**REQUEST FOR QUOTE (RFQ) - Bid #7464395
RHODE ISLAND STATE POLICE HEADQUARTERS PARKING IMPROVEMENTS**

**ADDENDUM #4
May 31, 2013**

**Exhibit (A)
Addendum 2
May 20, 2013**

ADDENDUM # 2

DRAWING TITLE:
SITE LAYOUT PLAN

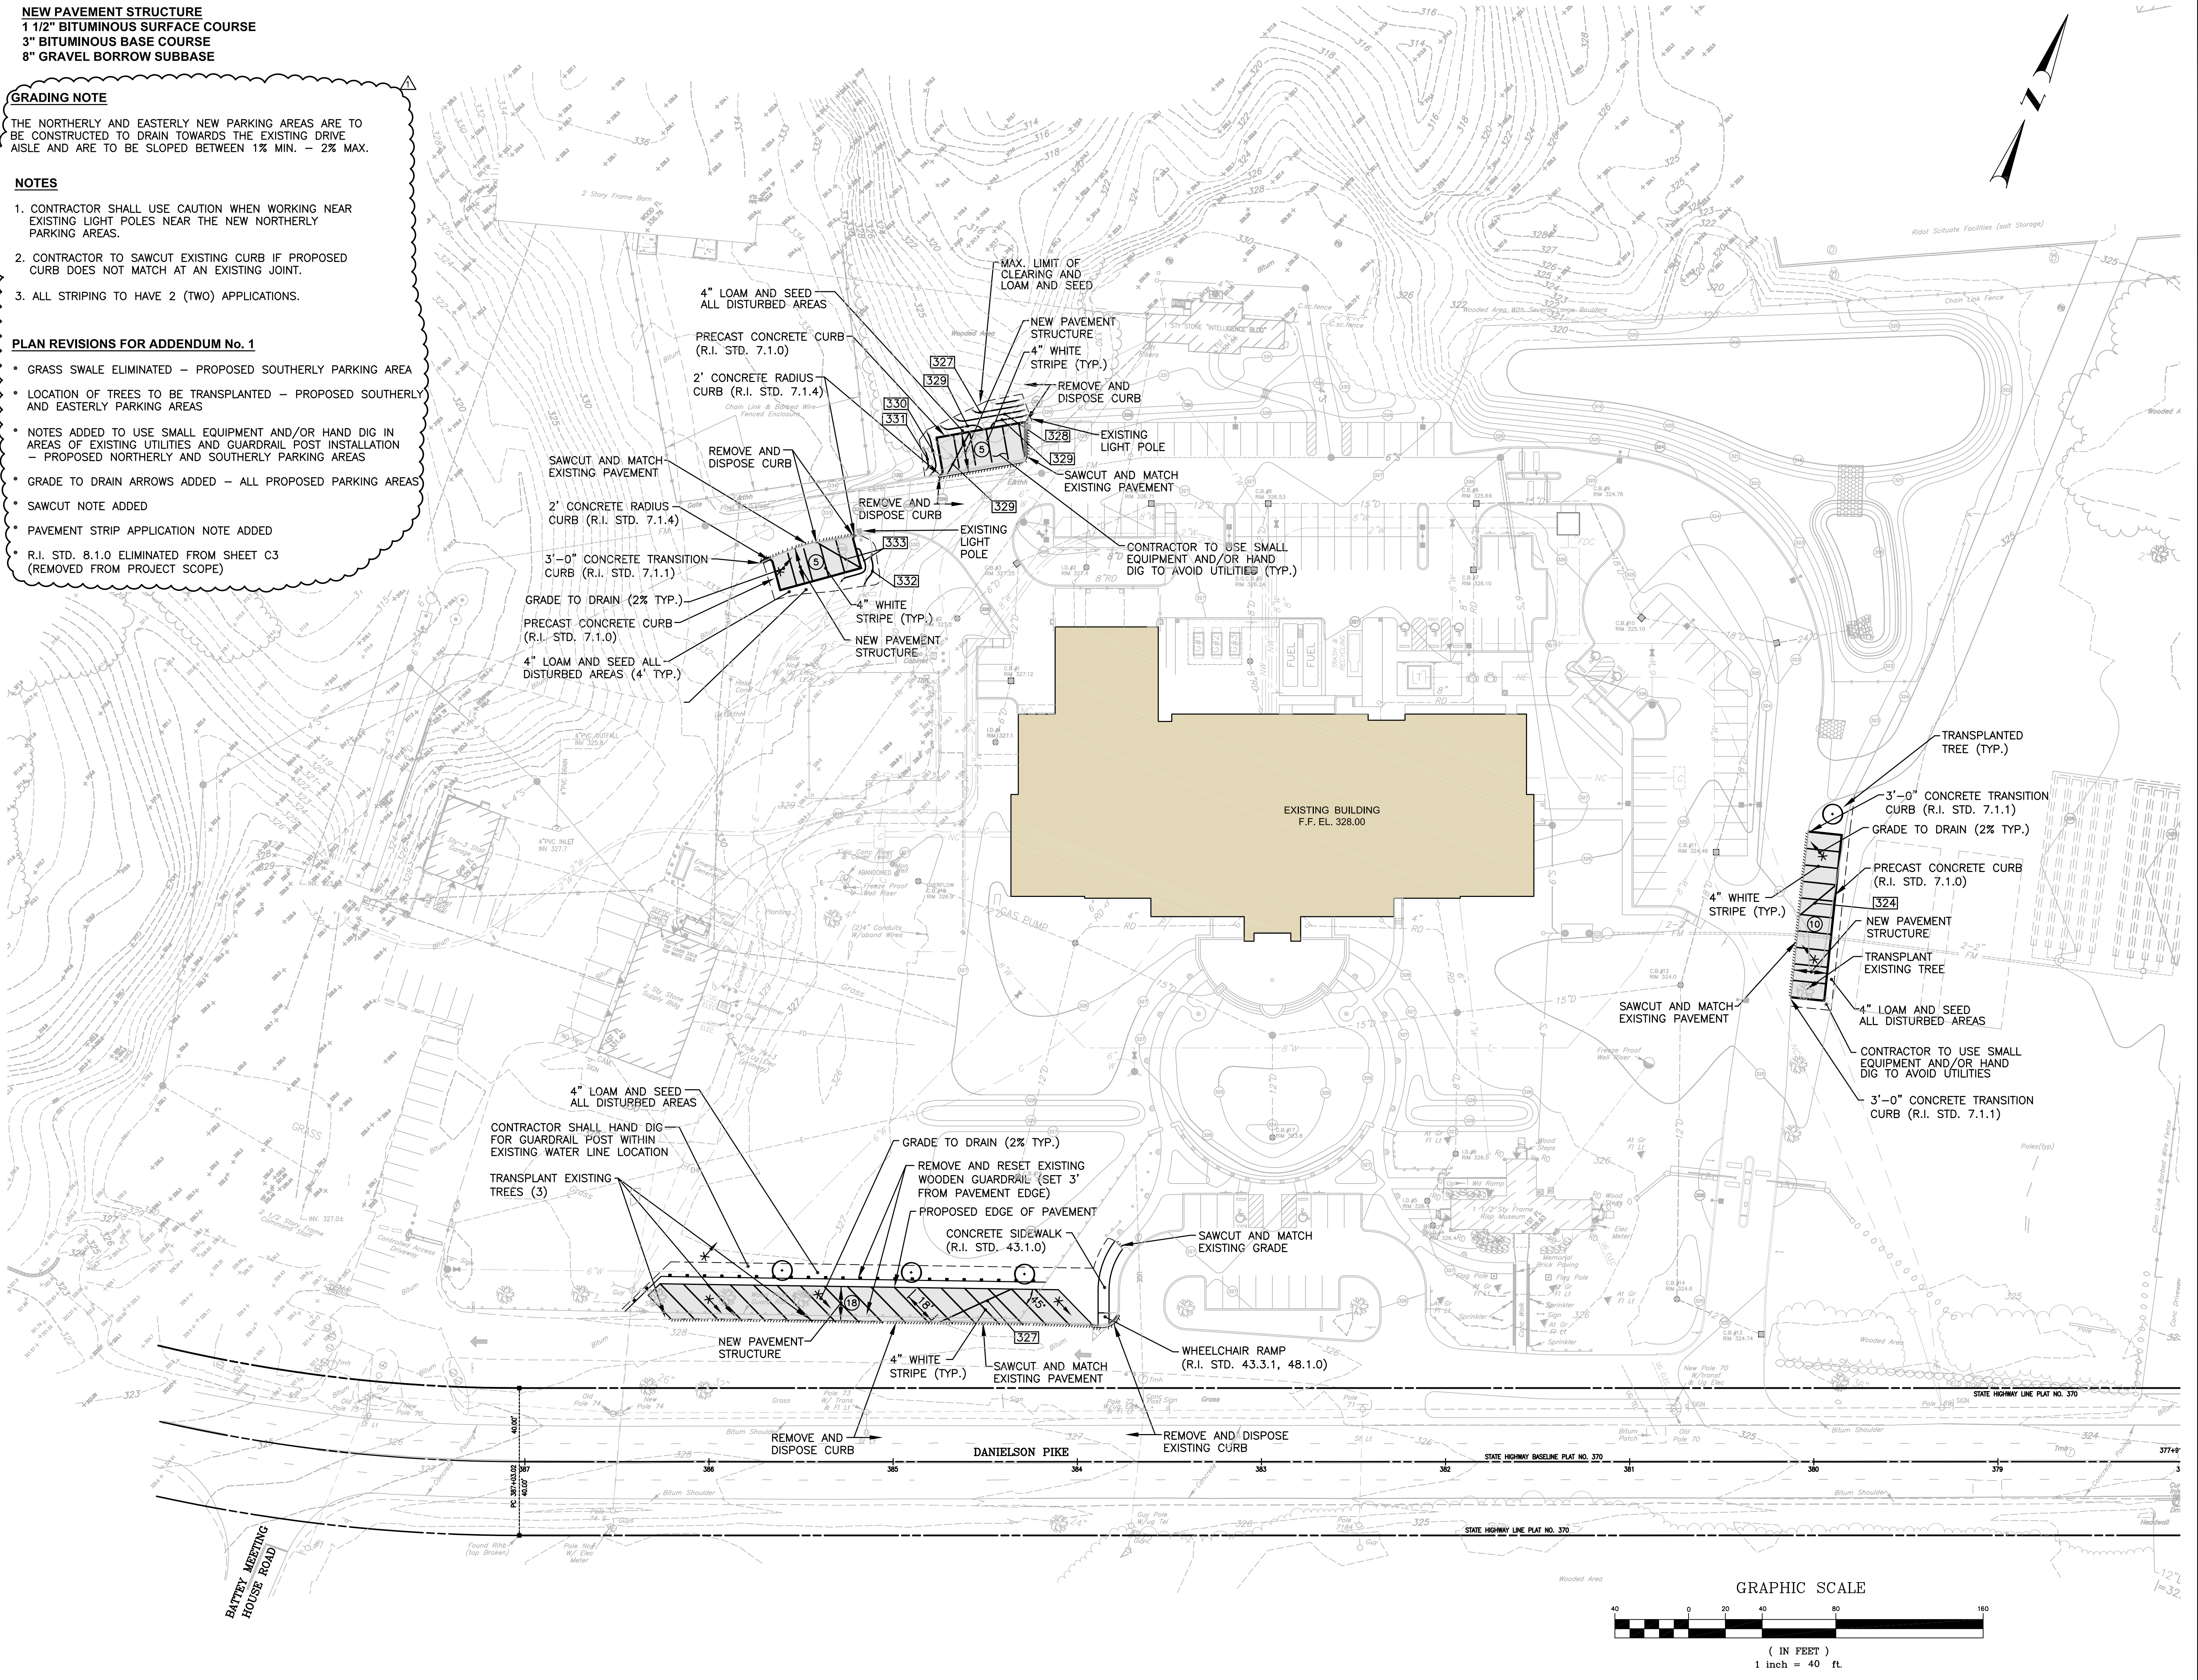
Question 10. Drawing number C-2 indicates trees to be transplanted. Where are the locations for the transplanted trees?

- GRASS SWALE ELIMINATED - PROPOSED SOUTHERLY PARKING AREA
- LOCATION OF TREES TO BE TRANSPLANTED - PROPOSED SOUTHERLY AND EASTERLY PARKING AREAS
- NOTES ADDED TO USE SMALL EQUIPMENT AND/OR HAND DIG IN AREAS OF EXISTING UTILITIES AND GUARDRAIL POST INSTALLATION - PROPOSED NORTHERLY AND SOUTHERLY PARKING AREAS
- GRADE TO DRAIN ARROWS ADDED - ALL PROPOSED PARKING AREAS
- SAWCUT NOTE ADDED
- PAVEMENT STRIP APPLICATION NOTE ADDED
- R.I. STD. 8.1.0 ELIMINATED FROM SHEET C3 (REMOVED FROM PROJECT SCOPE)

A. See attached Revised C-2 Drawing.
